1.1 ADDENDUM

1.2 DRAWING AND SPECIFICATION CHANGES

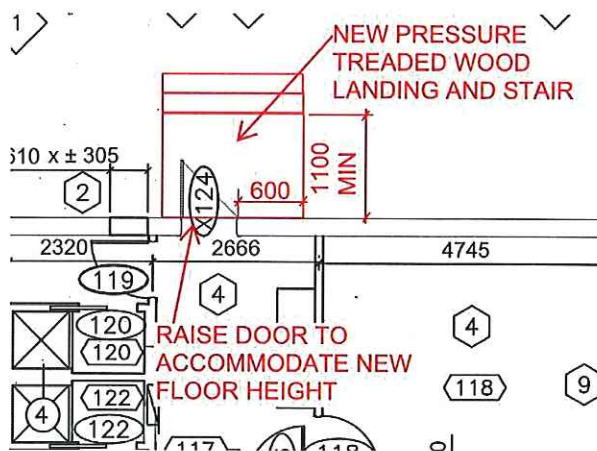
- .3 Remove existing wood landing and provide new pressure treated wood landing and stair as indicated below:
